UNITED STATES PATENT AND TRADEMARK OFFICE

09/863,013

Office Action Summary

DETAILED ACTION

**FIG. 1**

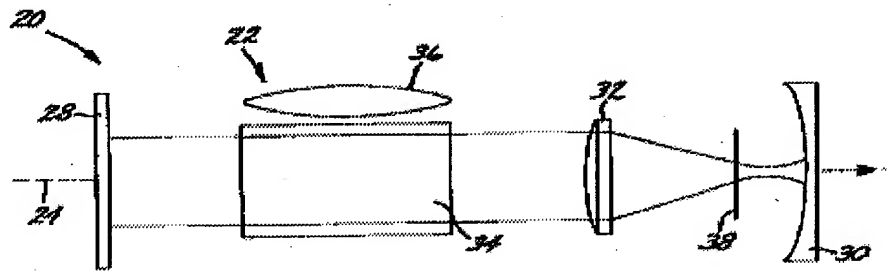
Regarding claim 16, Stultz et al. disclose a laser system, comprising:

a). a laser resonator cavity defined by a flat mirror (28) and an out coupler mirror (30), flat mirror (28) and said outcoupler (30) mirror oriented to form an optical resonant axis (24);

b). a lasing element (34) within the laser resonator cavity;

c) Optical pumping (36) means proximate to said lasing element

d). A saturable absorber Q-switch (38) lying along the resonant axis. (See Fig 1 below and column 3, line 14-21).

But Stultz et al. do not disclose the Q-switch including a monocrystalline lattice having a formula $Mg_{1-x}Co_xAl_yO_z$. However, Konstantin v. Yumashev and Thony et al. disclose a monocrystalline lattice having a formula $Mg_{1-x}Co_xAl_yO_z$ where x, y, z are still the range of the invention (See on the right column, first paragraph, page 1 of Konstantin v. Yumashev and column 2, line 38-47 in Thony et al.).
